**ADDENDUM NO. 5
IRONDALE PUBLIC LIBRARY**

CITY OF IRONDALE

THIS ADDENDUM FORMS A PART OF THE CONTRACT DOCUMENTS. THE FOLLOWING CONDITIONS TAKE PRECEDENCE OVER ANY CONFLICTING CONDITIONS IN THE DRAWINGS AND SPECIFICATIONS. THE DRAWINGS AND SPECIFICATIONS ARE HEREBY AMENDED IN THE FOLLOWING PARTICULARS.

E003

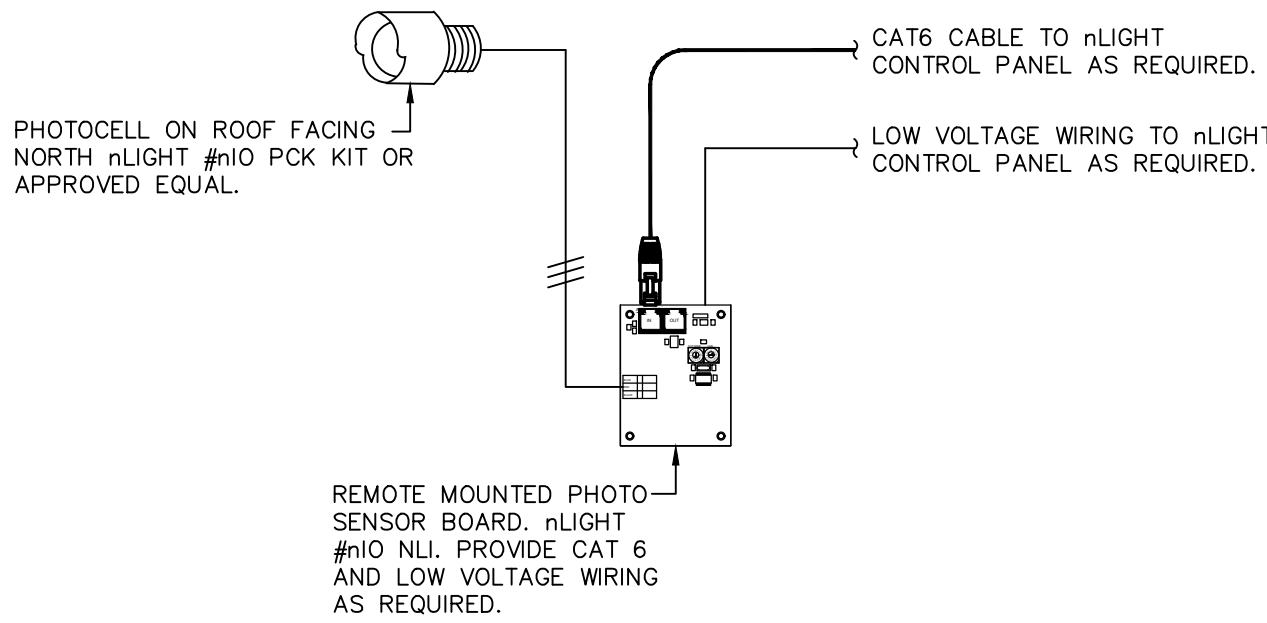
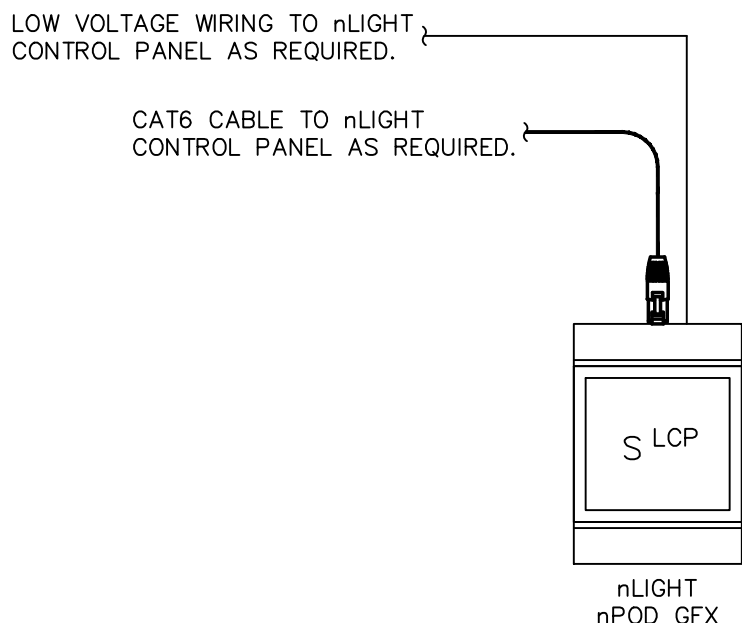
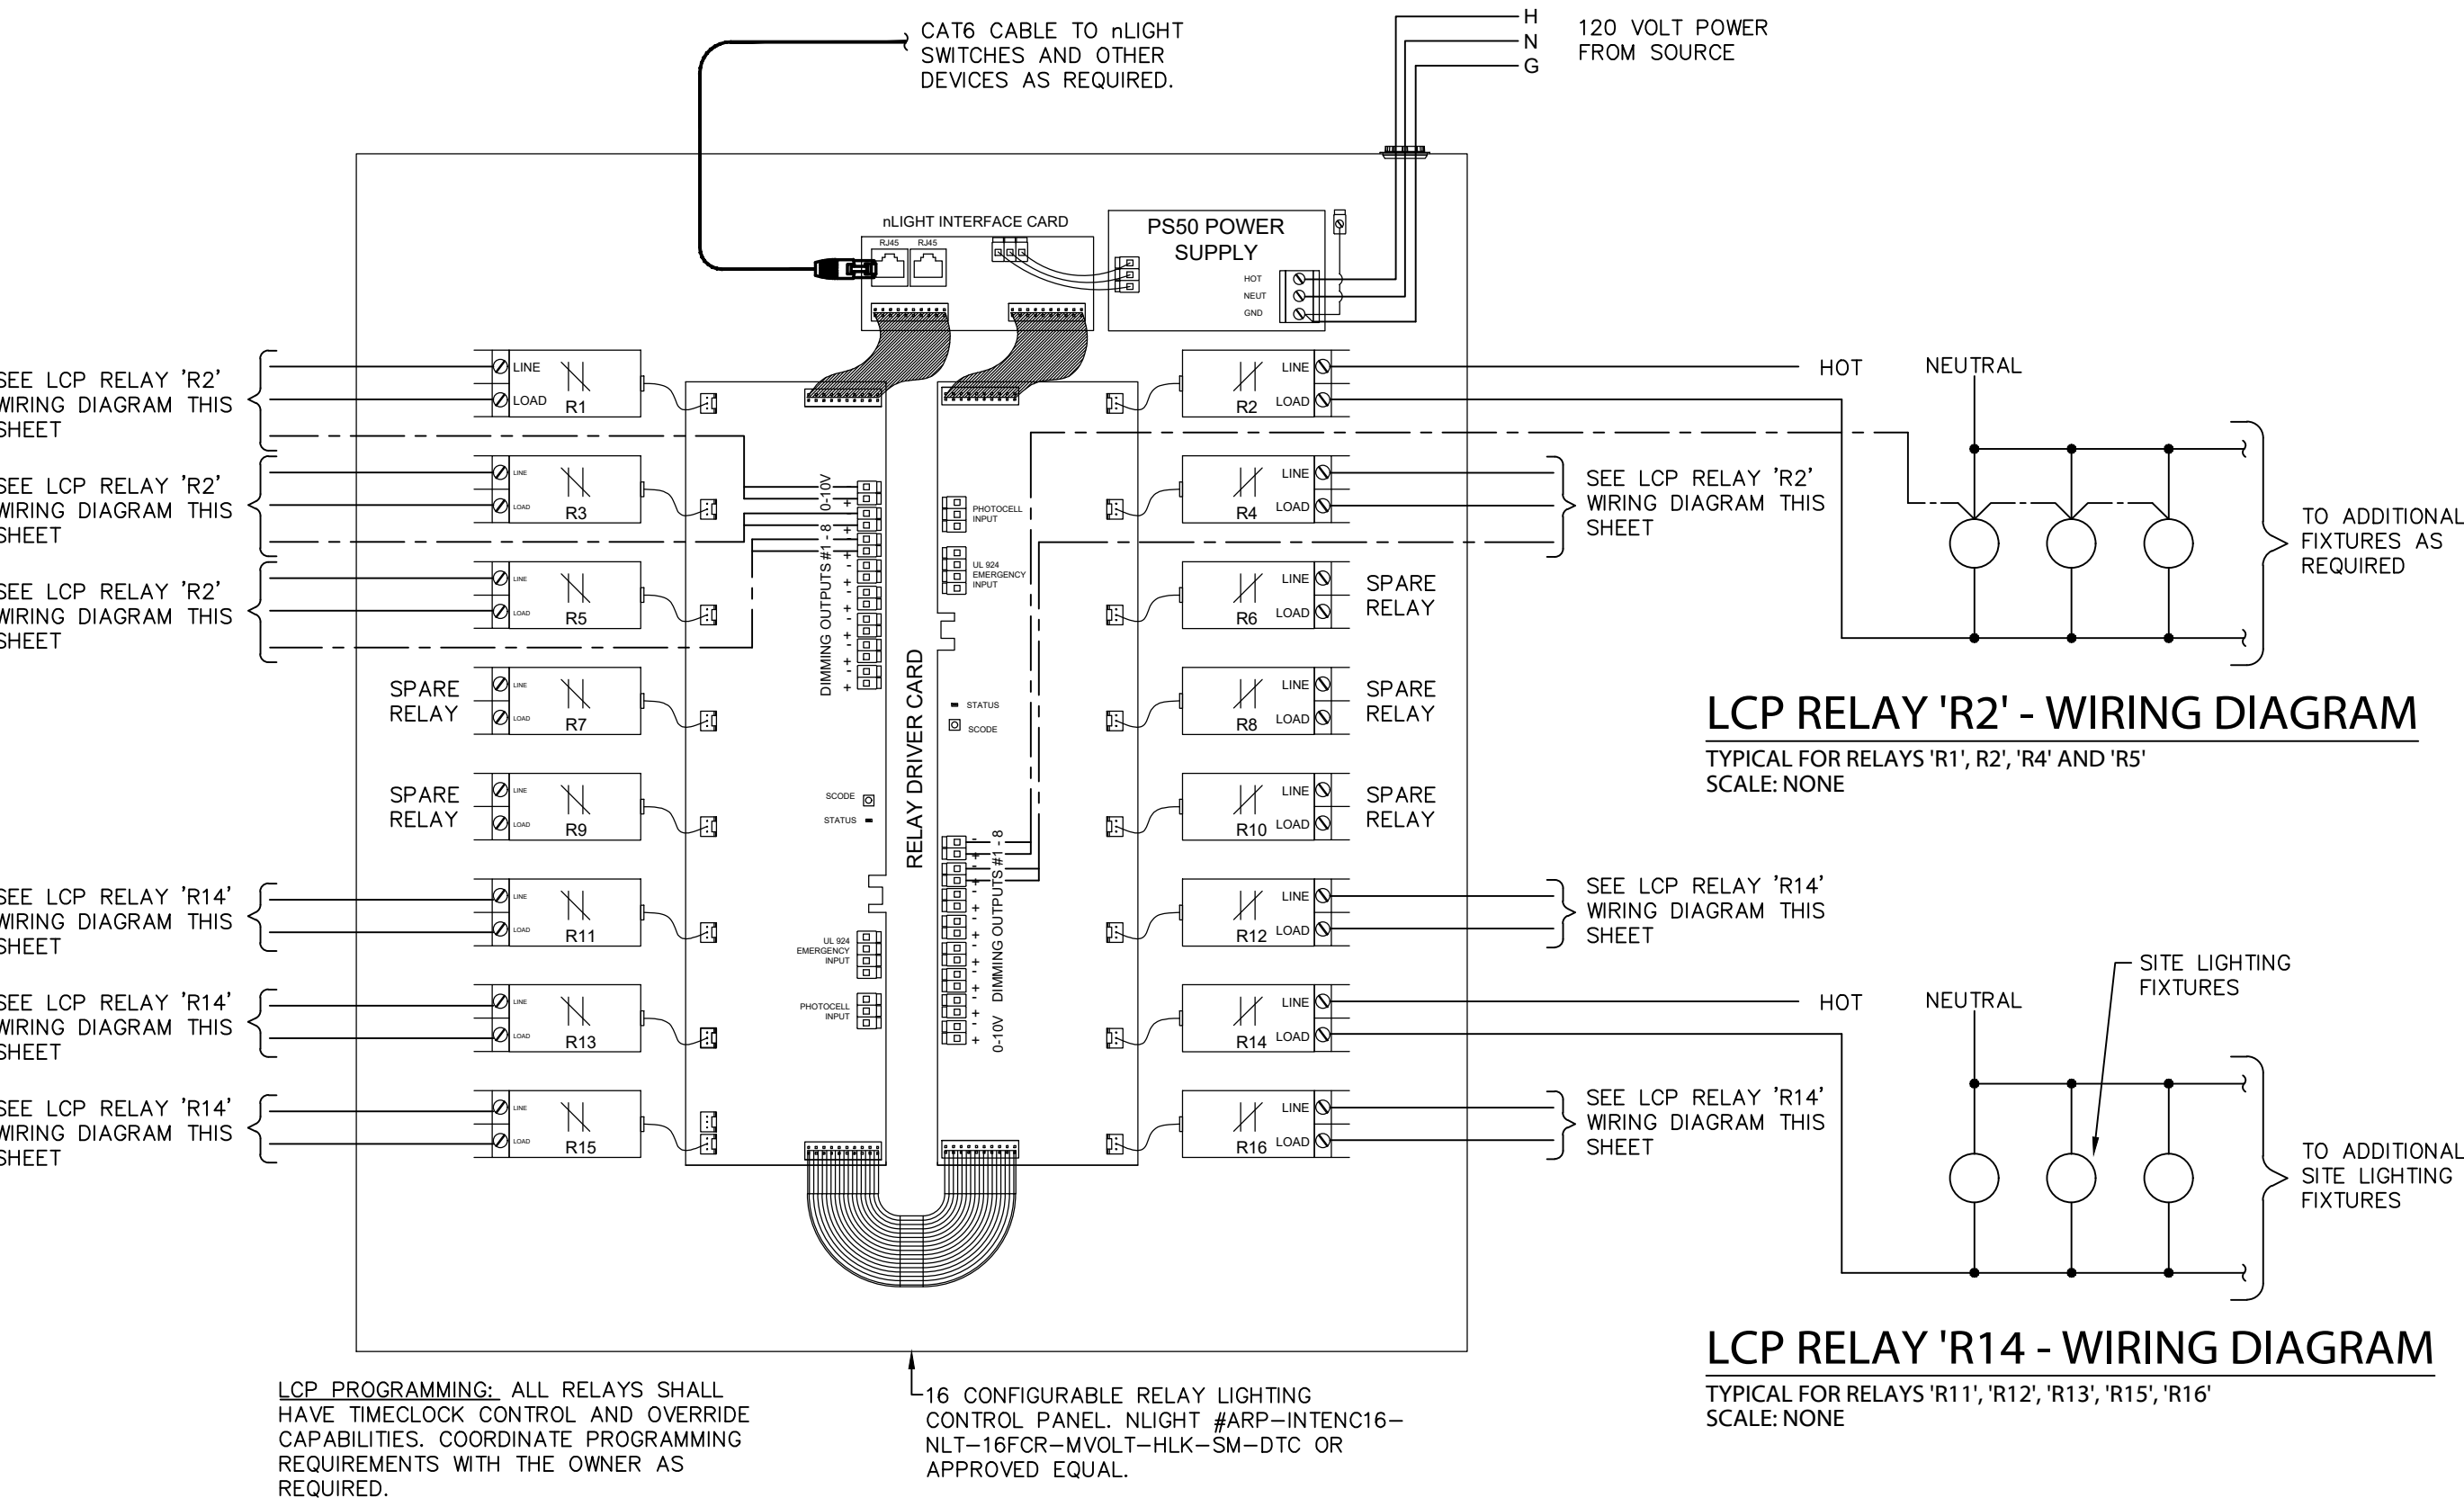
9. Sheet E003
 - a. Deleted Timeclock Wiring Diagram Detail.
 - b. Added Detail for Lighting Control Panel.
10. Sheet E005
 - a. Added biscuit jack clarification to Wireless Access Point Detail.

E101

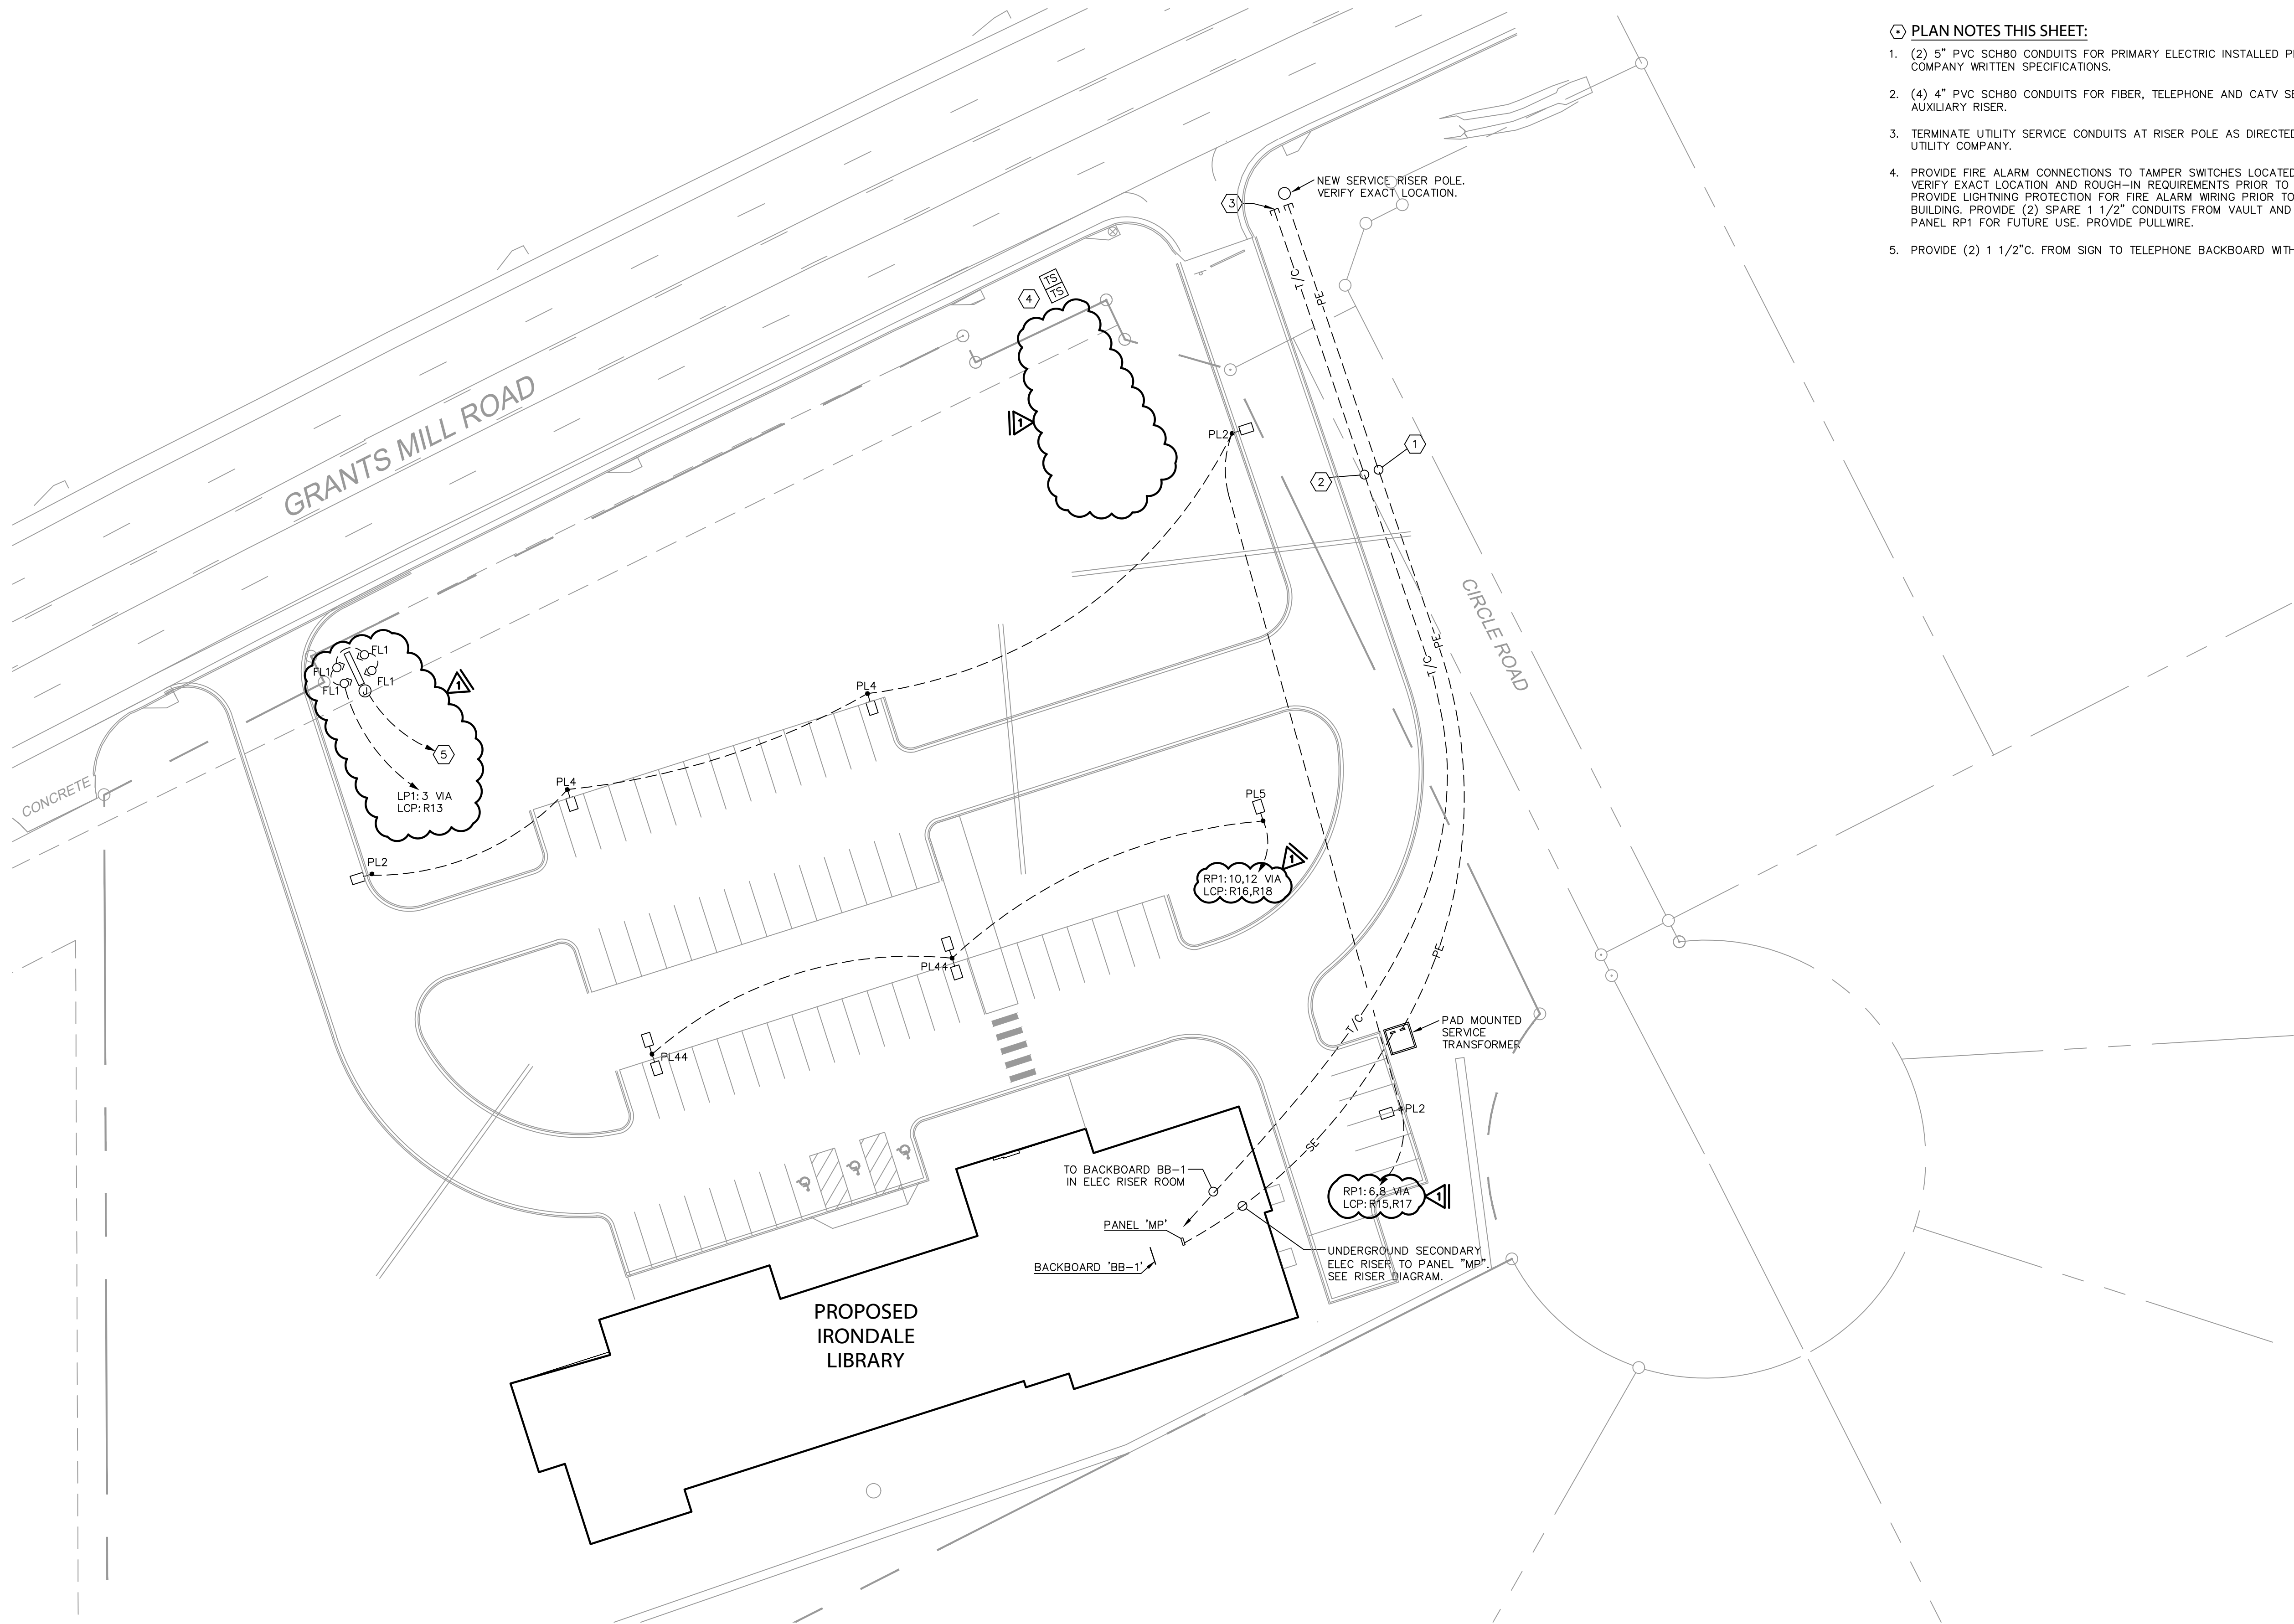
- a. Moved monumental sign. Coordinate the exact location with the civil drawings.
 - b. Updated circuiting requirements for the site.
- 12. Sheet E201
 - a. Light fixture designations modified to reflect additional fixtures that will require battery back-up.
 - b. Removed two (2) exit signs at entry lobby.
 - c. Added General Note 'D'.
- 13. Sheet E202
 - a. Added cabling requirements for Wireless Access Points.
 - b. Added plan note designations to floor boxes that were not identified.
- 14. Sheet E203
 - a. Added duct mounted smoke detectors at roof top unit as required.

- 2. Light Fixture 'PL2' quantity of (3) on electrical drawing E101 is shown as a single head but on the lighting schedule on electrical drawing E002 fixture 'PL2' is listed as a double-head. Please clarify.

Response: Fixture shall be single head.
- 3. Light fixture 'PL4' quantity of (2) on electrical drawing E101 is not listed on the lighting schedule on electrical drawing E002. Please provide a part number.
